AGENDA - LPP

Meeting:	Georges River Local Planning Panel (LPP)
Date:	Thursday, 15 October 2020
Time:	4.00pm
Venue:	Council Chambers, Civic Centre, Hurstville
Panel Members:	Paul Vergotis (Chairperson) Helen Deegan (Expert Panel Member) John Brockhoff (Expert Panel Member) George Vardas (Community Representative)

**REPORT TO GEORGES RIVER COUNCIL
LPP MEETING OF THURSDAY, 15 OCTOBER 2020**

LPP Report No	LPP049-20	Development Application No	DA2020/0247
Site Address & Ward Locality	117 Stuart Street Blakehurst Blakehurst Ward		
Proposed Development	Demolition, tree removal, construction of a multi level dwelling house, in-ground swimming pool, front fencing, landscaping and site works		
Owners	Gemaveld Pty Ltd		
Applicant	MKD Architects		
Planner/Architect	Planner: BMA Urban; Architect: MKD Architects		
Date Of Lodgement	19/06/2020		
Submissions	One submission		
Cost of Works	\$4,362,857		
Local Planning Panel Criteria	The proposal seeks a variation to the maximum FSR development standard that is greater than 10%.		
List of all relevant s.4.15 matters (formerly s79C(1)(a))	State Environmental Planning Policy No 55 - Remediation Of Land; State Environmental Planning Policy (Infrastru

17. The proposed site plan is shown in Figure 1 and the proposed levelling and landscaping of the site and the rear yard is shown in Figures 2 and 3.

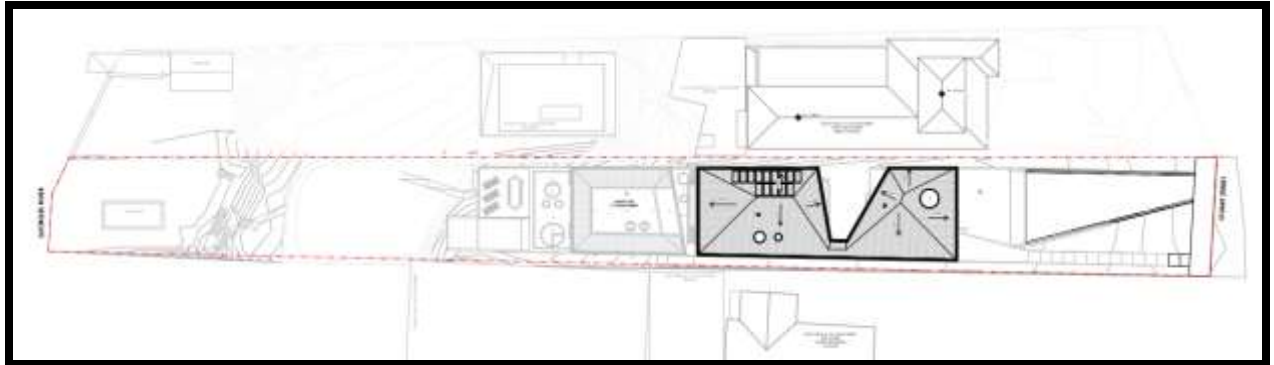
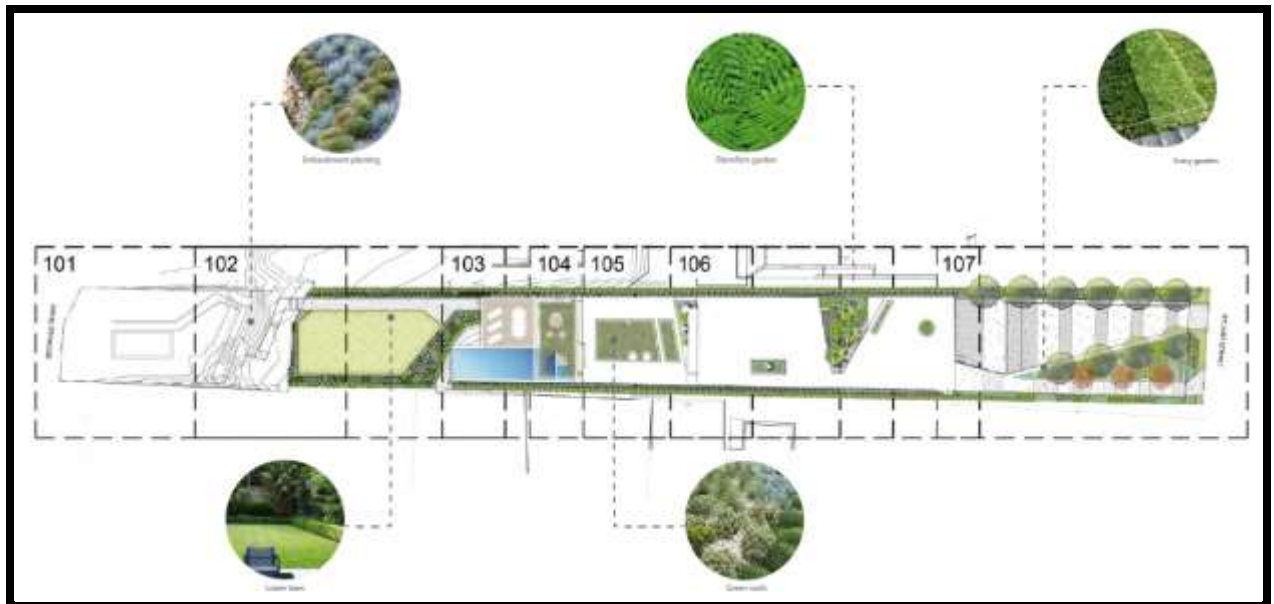
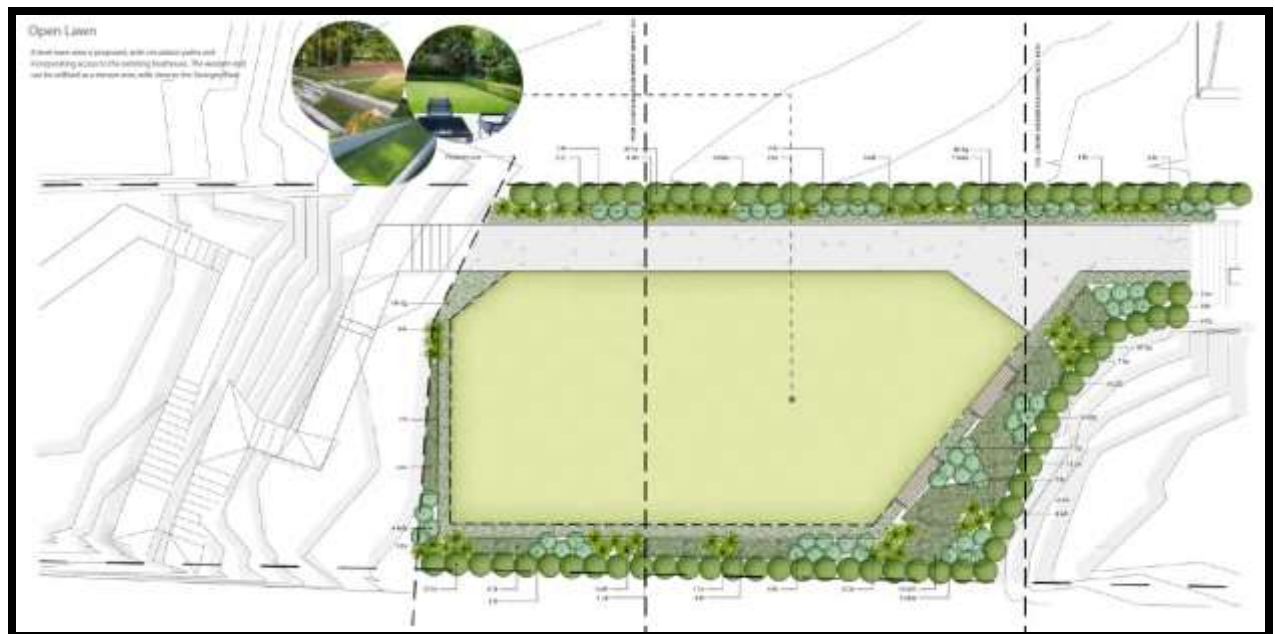
Significant earthworks are proposed to accommodate the lower levels of the proposed dwelling and to level the site to provide a flat lawn area at the rear of the dwelling. The site currently retains the natural topography of the land between the dwelling and the foreshore. The proposal involves excavation of up to 10m to accommodate the three lower levels of the dwelling, and cut and fill at the rear of the dwelling to create a flat landscaped private open space area ground level.

The plans are not dimensioned to enable a proper assessment of the depth of the proposed cut and fill in this area, and no detail is provided on the required retaining walls around the area.

Figure 1: Site plan annotated with the inconsistencies measures and observed on site (provided to the applicant on 29 June 2020).

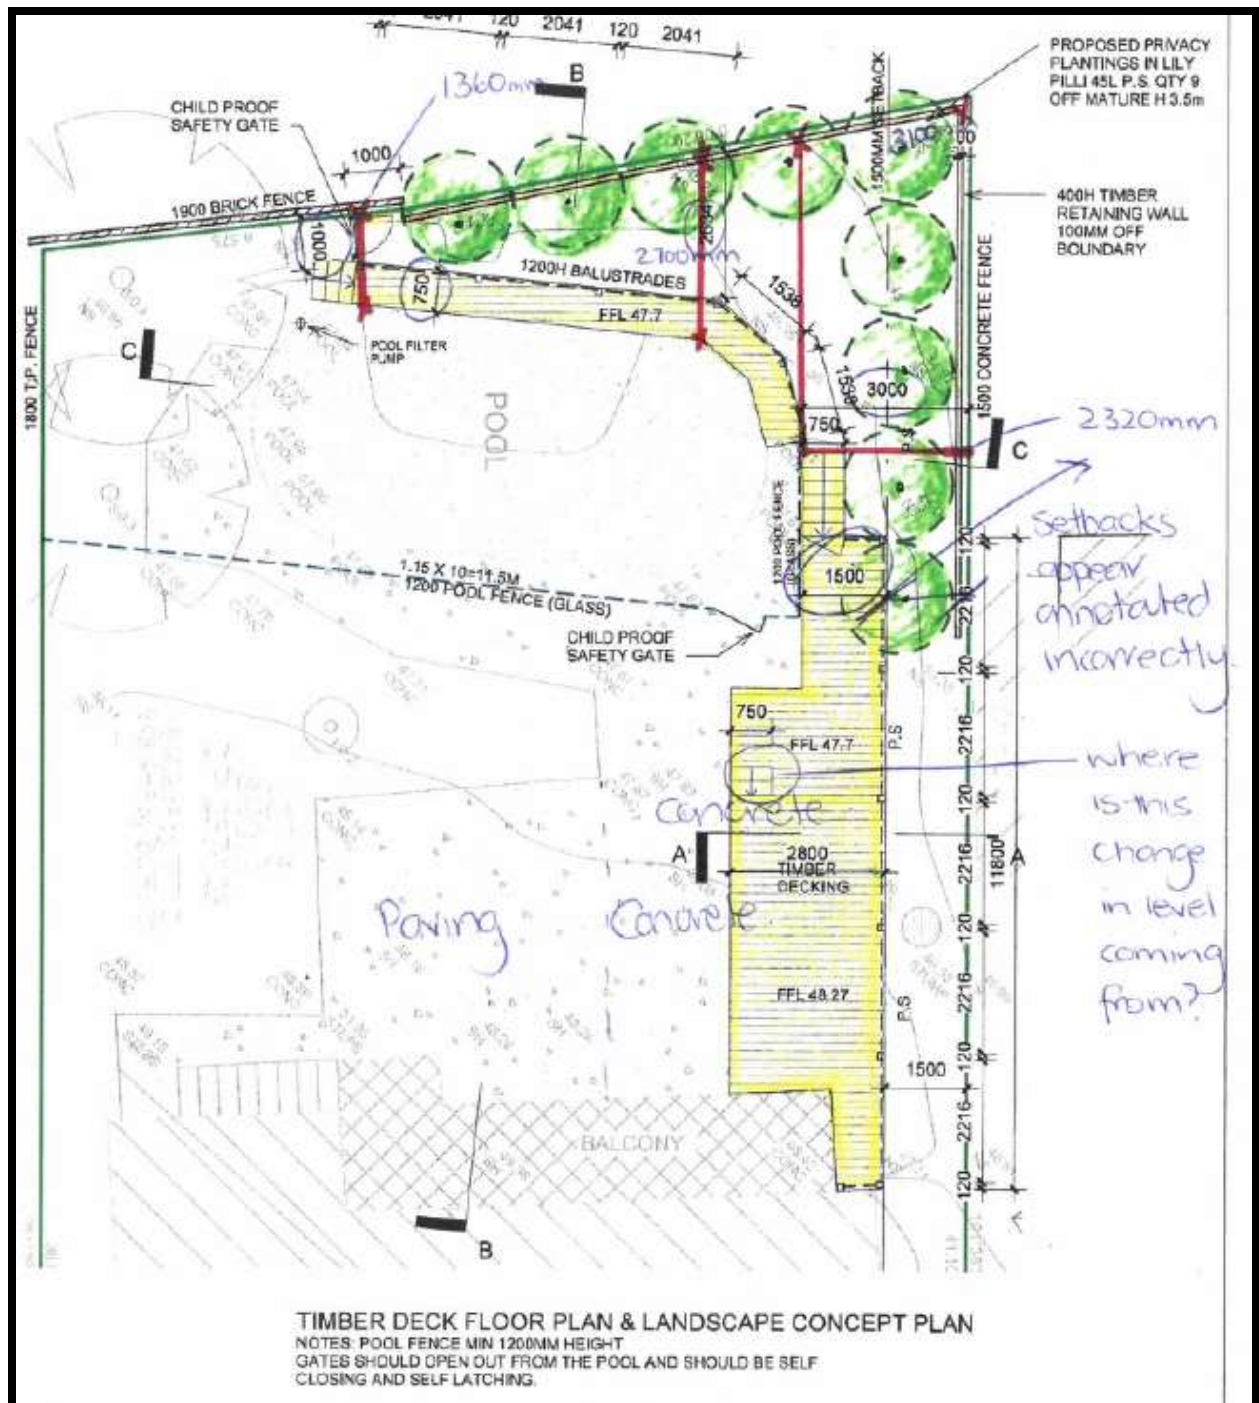
30. During the site inspection, it became evident many of the proposed setbacks (as shown on the DA plans) were incorrect. There were also other inconsistencies with the plans in relation to the deck interface with the dwelling, the location of pavers and concrete that is existing and the existing ground level in the area where the works are being undertaken.

31. To assist the applicant, Council Officers prepared an annotated plan and photos whilst on site to demonstrate the inconsistencies and the areas required to be addressed via amended plans. This annotated plan was forwarded to the designer on the 29 June 2020 as well as to the owner and again to the newly engaged designer on 2 September 2020. The following is an extract of the annotated plan that was provided to the applicant:

32. Amended plans were provided on 8 September 2020. The amended plans remain inaccurate and do not reflect what is on site or the correct setbacks of the existing swimming pool, or existing site contours and levels. In addition the width of the decking and stairs have been increased in width, resulting in a worsening of the inaccuracies.

33. The amended plans have addressed some of the areas of inconsistency, but a majority of the inconsistencies remain. These include the dimensions to the rear setback. Figure 1 demonstrates that the rear setback (from the western boundary) was measured to be 1360mm however the dimensions shown on the plan in Figure 2 is 970mm+800mm which is 1770mm and inconsistent with the measurements taken on site. The existing ground floor level and interface with the dwelling also remains incorrect.

Figure 10: Extract of cross section plan of proposed studio layout, with living/dining and bedroom nook located behind the bathroom (Source: Locus Architects, 2020).

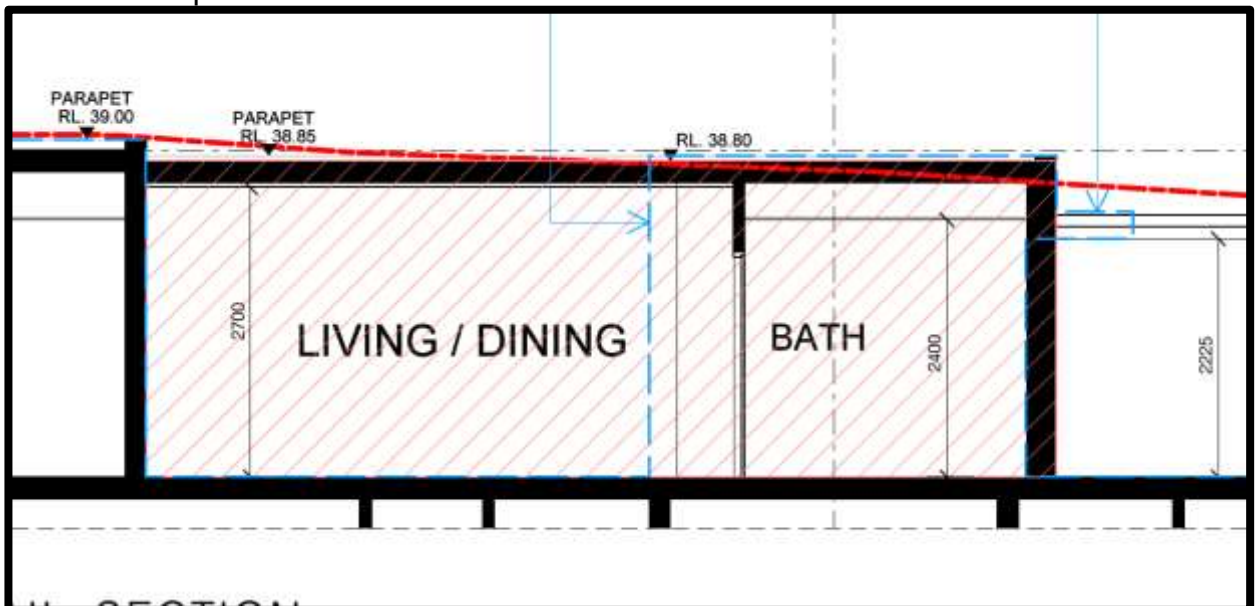
The Apartment Design Guide prescribes a minimum floor to ceiling height of 2.7m for habitable rooms and 2.4m for non-habitable rooms. An extract of the cross section has been provided below which demonstrates that the amended proposal being a studio unit now complies.

Figure 12: Extract of cross section of proposed studio unit (Source: Loucas Architects, 2020).

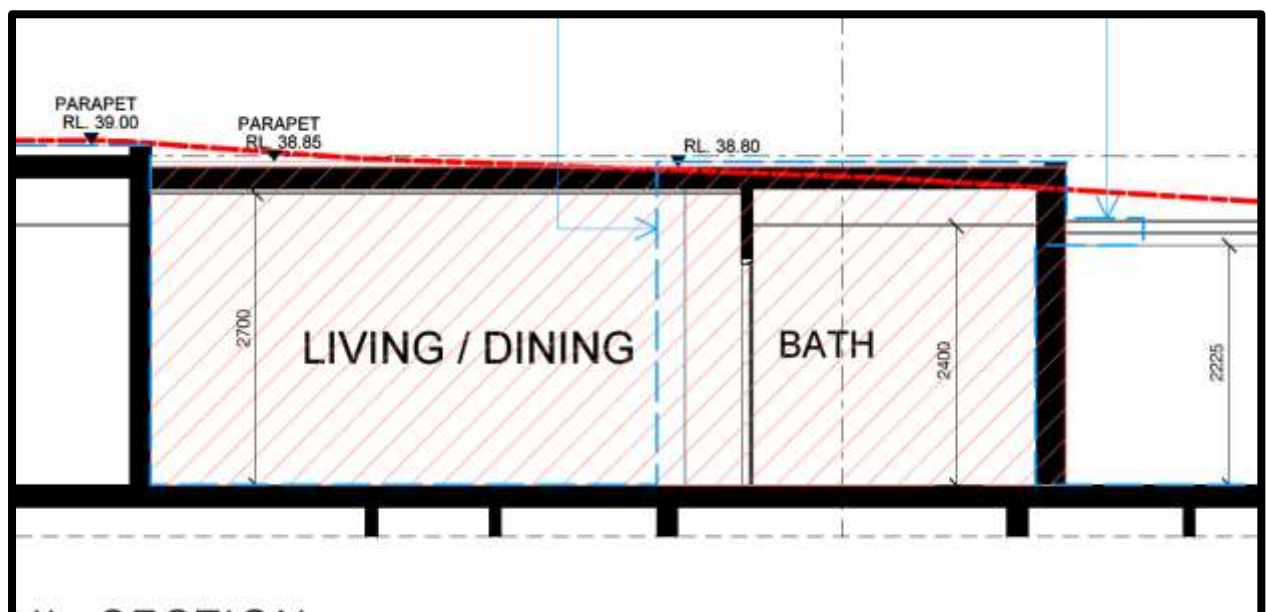
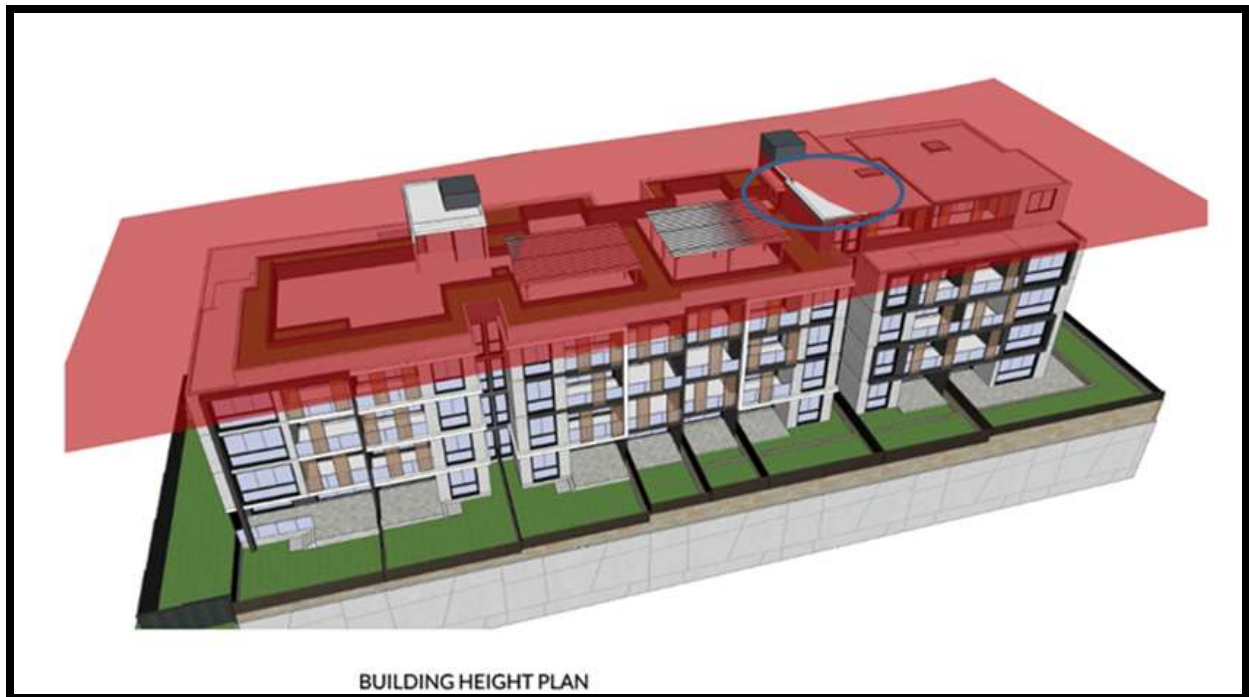
72. The Kogarah LEP 2012 prescribes a maximum building height of 15m for this site.
73. The proposal does not comply with the 15m height control of the Hurstville LEP 2012. The extent of the non-compliance, at the highest point being the above the proposed living room of the unit equates to 275mm or 1.8% above the 15m height limit for a length of 3.77m which is considered to not be out of character with recently approved developments. The extent of the breach is limited to the roof slab thickness.

79. Officer Comment: The applicant's justification is supported. As shown in the section (Figures 12 and 13), the extent of the height variation relates to the roof slab of top of the proposed unit which is centrally sited within the building footprint. The proposed variation does not comprise of floor space or area which could be readily converted into floor space, it is merely the roof slab thickness.

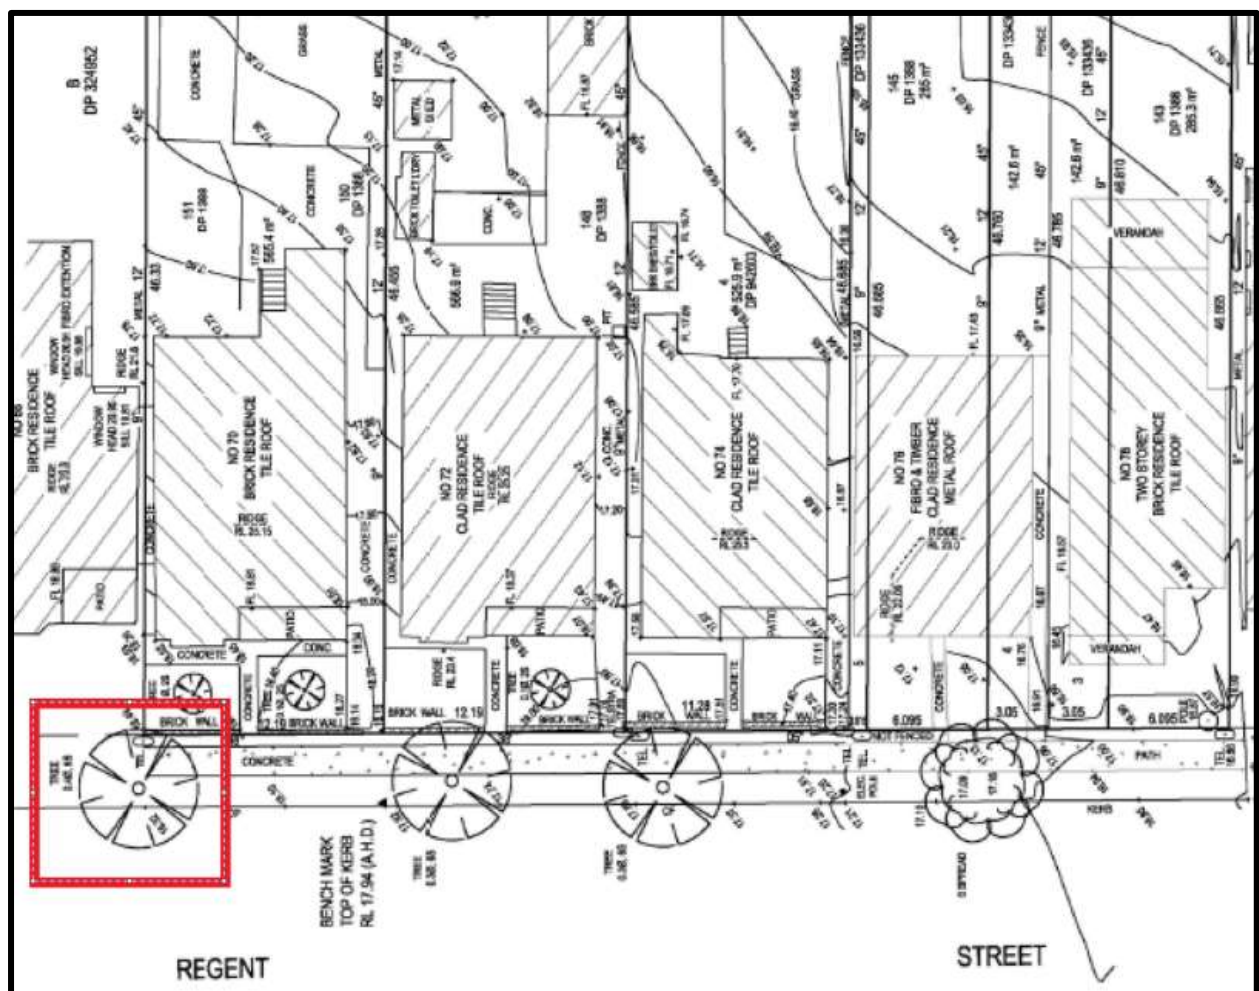
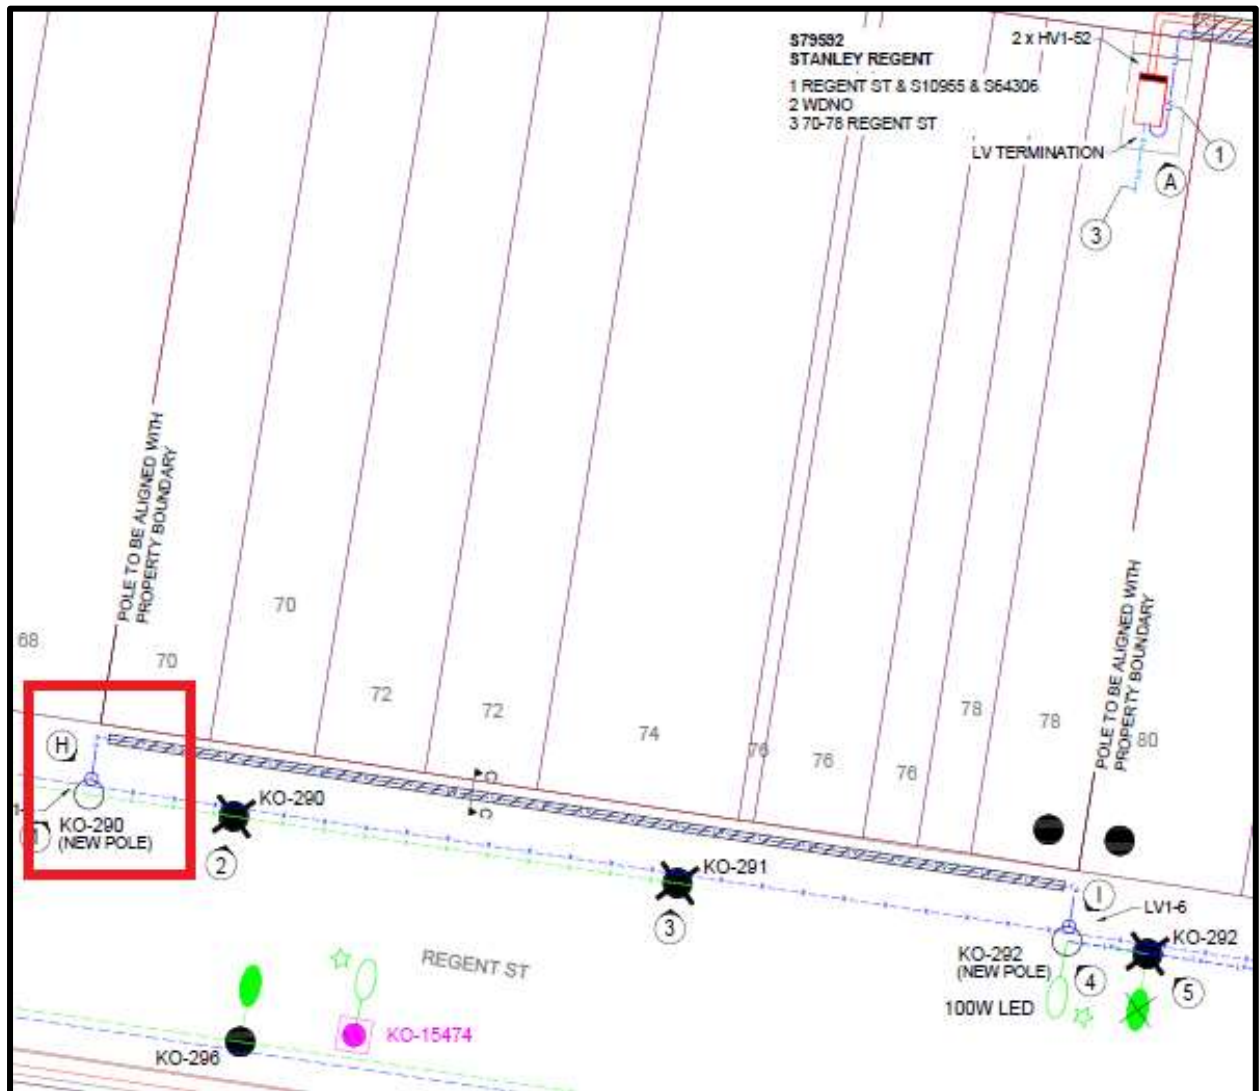
1.2.2 Building Heights	<p>(1) The maximum building height must comply with the requirements specified in table below:</p> <p>Dwelling Type Single dwelling;</p> <p>Maximum Height 7.2m to the underside of the upper ceiling; 7.8m to the top of the parapet;</p>	The proposal, in parts, exceeds the 7.2m ceiling height and 7.8m parapet height; however no spot levels are provided on the plans to confirm the existing ground level of the site.	No.
